Subject: AP1000 Response to Request for Additional Information (SRP 3)

# AP1000 TECHNICAL REPORT REVIEW

RAI Response Number: RAI COL03.05.01.04-1

RAI Response Number: OI-SRP3.3.2-SEB1-01

Figure OI-SRP3.3.2-SEB1-01 – Siding Impact on Shield Building

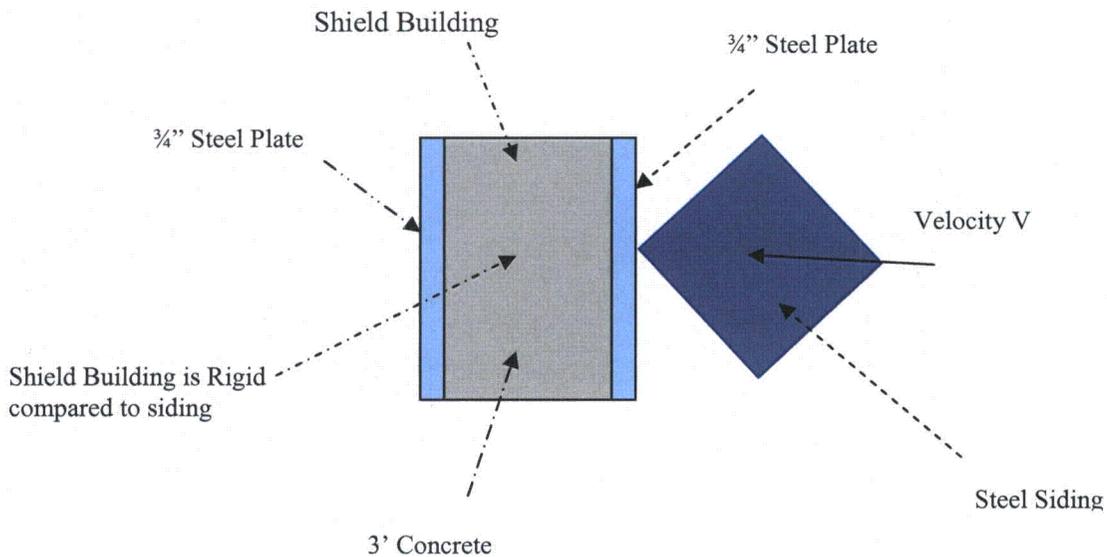
1. Provide quantitative evaluation the damage of a siding missile impact on steel plates and the potential for creating a non-stable crack. Siding is representative, corrugated type siding.
2. Include description of siding missile in DCD.

Conservatively, a three foot square portion of siding is assumed to impact the cylindrical portion of the shield building that would result in the maximum impact load. The three foot square was chosen since the siding is in three foot strips, and it is necessary to have the center of gravity of the siding in line with the point of impact so no rotation occurs. Rotation would lessen the effect of the impact. The siding impact on the shield building is shown in Figure OI-SRP3.3.2-SEB1-1.

Figure RAI-SRP3.7.1-SEB1-06-1: X-Direction Comparison

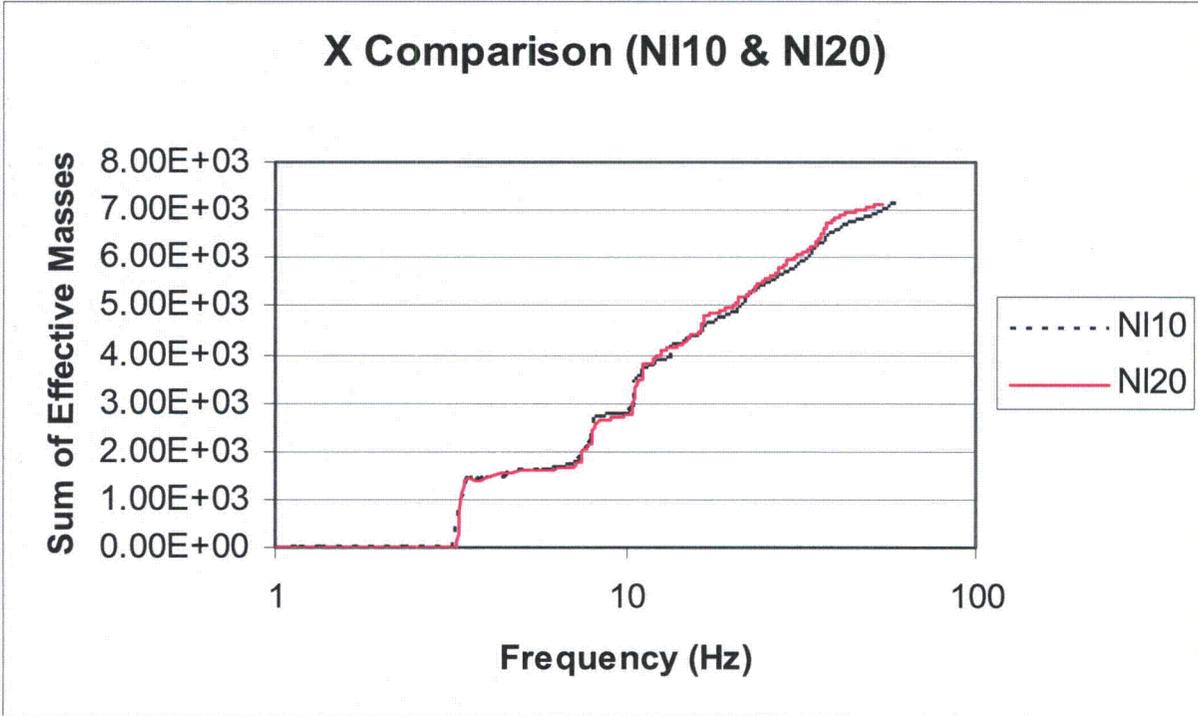
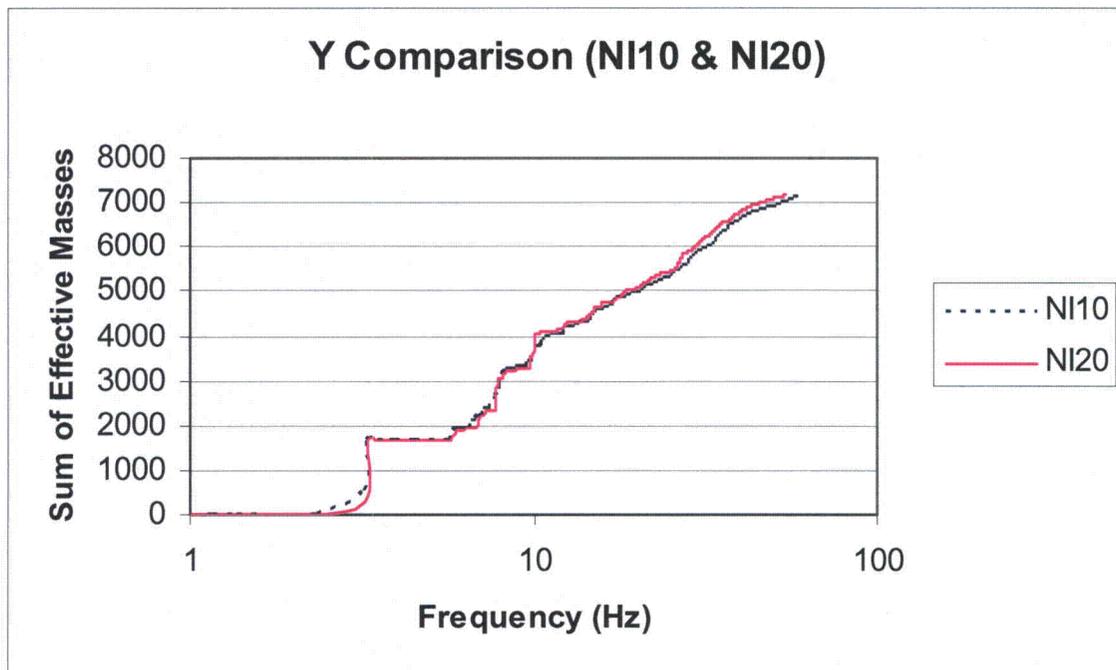
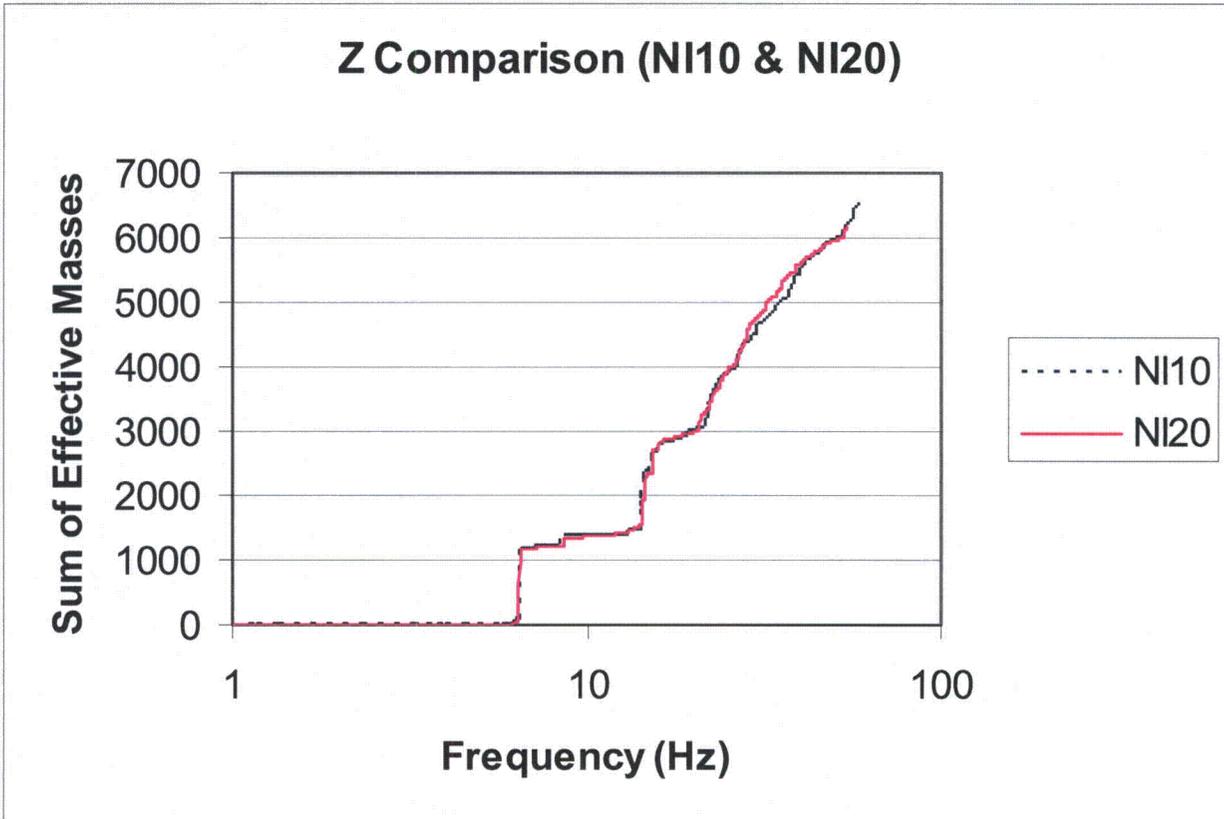
Westinghouse's calculation in TR-115 indicates 4 points per wavelength for 80 Hz. This is the bare minimum to represent a full cycle of sinusoidal displacement variation. The staff requests that Westinghouse include in Section 5.1 a comparison of frequencies and mode shapes between the NI10 and NI20 models, as an alternate way to demonstrate the adequacy of the NI20 model to accurately predict high frequency modes (up to 80 Hz).

The staff initially requested that Westinghouse include in Section 5.1 of TR 115, a comparison of frequencies and mode shapes between the NI10 and NI20 models, as an alternate way to demonstrate the adequacy of the NI20 model to accurately predict high frequency modes (up to 80 Hz). In its initial response, Westinghouse pointed out that the final ISG for addressing HRHF GMRS only requires modeling refinement to accurately predict up to 50 Hz. Instead of providing a comparison of frequencies and mode shapes between the NI10 and NI20 models up to 50 Hz, Westinghouse indicated that there are 7 nodes per wavelength in the NI20 model for a 50 Hz frequency. In a supplement to its initial response, as a result of discussions at the May 2008 onsite audit, Westinghouse presented additional information about the frequency distributions in the NI10 and NI20 models, and claimed that this information demonstrated adequacy of the NI20 model up to 50 Hz.

Figures RAI-SRP3.7.1-SEB1-06-1 to RAI-SRP3.7.1-SEB1-06-3 show a summation of the of the effective mass versus frequency for the X, Y and Z directions. The effective masses associated with the NI20 and NI10 models compare closely over the frequency range of 1 to 80 Hz.

From this comparison it can be concluded that the modal response of the NI20 model is very similar to the NI10 model, and therefore, is adequate to predict the high frequency response up to 50 hertz.

Figure RAI-SRP3.7.1-SEB1-06-04: HRHF Acceleration Response Spectra

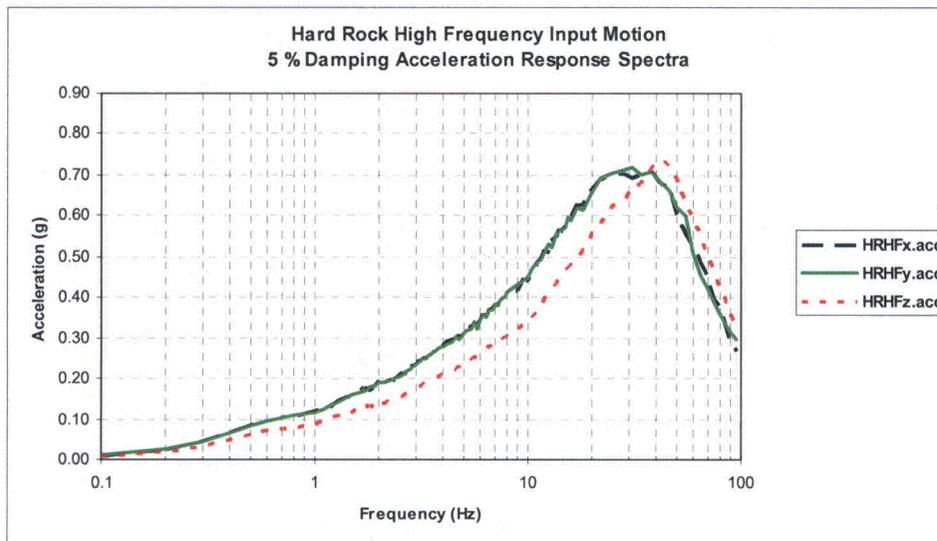
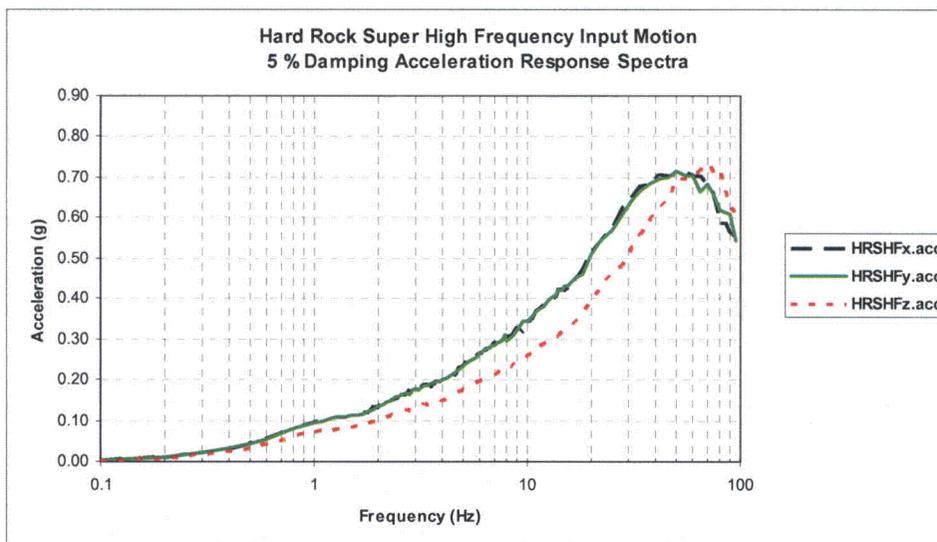
Please provide more detail.

The HRHF spectra peaks at about 25 Hz. In order to confirm the NI20 model’s adequacy for frequencies up to 50 Hz, a time history analysis was performed in ANSYS using the NI20 and NI10 models with the Westinghouse defined Hard Rock High Frequency (HRHF) input time history. The time step for the HRHF time history was changed from 0.005 to 0.003 seconds. This shifts the peak of the input time history to 50 Hz while maintaining the statistically

indeterminate properties of the original HRHF spectra defined in TR115. We shall refer to this as the Hard Rock Super High Frequency (HRSHF) analysis in subsequent discussions. The HRHF and HRSHF acceleration response spectra have been provided in Figures RAI-SRP3.7.1-SEB1-06-04 and RAI-SRP3.7.1-SEB1-06-05 to show the acceleration peak shift due to the time step change.

Figure OI-SRP3.7.2-SEB1-02-1 – Radwaste Monitor Tank

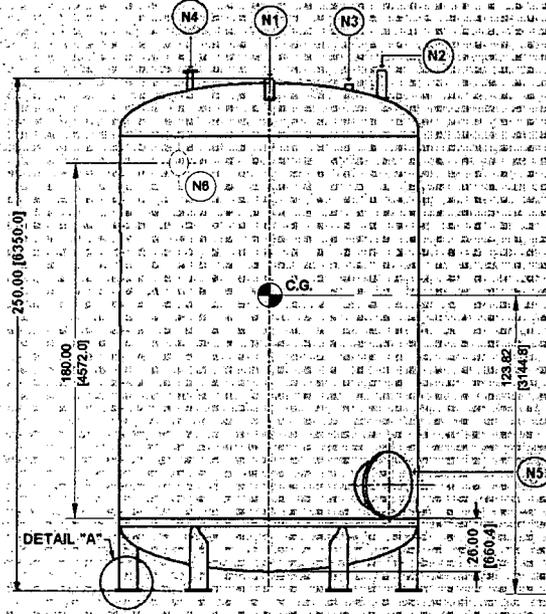
Evaluate the capability of a radwaste monitor tank to remain in place when exposed to tornado wind loads. The evaluation is to be based on the Class D level component analysis and building code structural evaluation.

The Radwaste monitor tank is shown in Figure OI-SRP3.7.2-SEB1-02-1. It is supported by six supports as shown in Figure OI-SRP3.7.2-SEB1-02-2.

The center of gravity is near the center of the tank as seen in Figure OI-SRP3.7.2-SEB1-02-1. Therefore, the equivalent static load associated with the tornado will act very close to the equivalent static load associated with the seismic load. Therefore, it is only necessary to compare the load acting on the tank due to a tornado and seismic events. If the load from the
